Proposal for the 08 series of amendments to UN Regulation No. 48 (Installation of lighting and light-signalling devices)

Submitted by the Working Party on Lighting and Light-Signalling*

The text reproduced below was adopted by the Working Party on Lighting and Light-Signalling (GRE) at its eighty-fourth session (ECE/TRANS/WP.29/GRE/84, paras. 24, 25 and 27). It is based on ECE/TRANS/WP.29/GRE/2021/4, ECE/TRANS/WP.29/GRE/2021/5 and ECE/TRANS/WP.29/GRE/2021/8. It is submitted to the World Forum for Harmonization of Vehicle Regulations (WP.29) and to the Administrative Committee (AC.1) for consideration at their November 2021 sessions.

Model A

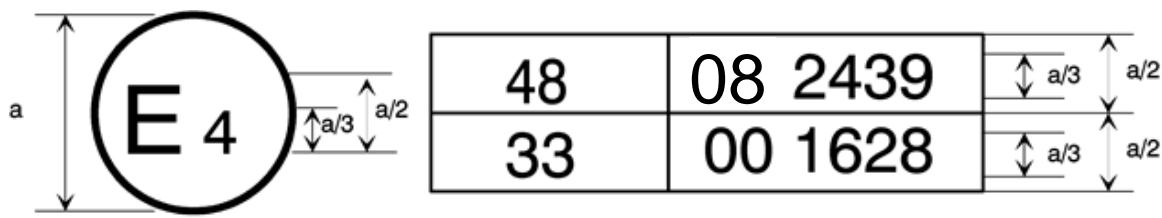
Annex 2, amend to read:

The above approval mark affixed to a vehicle shows that the vehicle type concerned has, with regard to the installation of lighting and light-signalling devices, been approved in the Netherlands (E 4) pursuant to UN Regulation No. 48 as amended by the 08 series of amendments. The approval number indicates that the approval was granted in accordance with the requirements of UN Regulation No. 48 as amended by the 08 series of amendments.
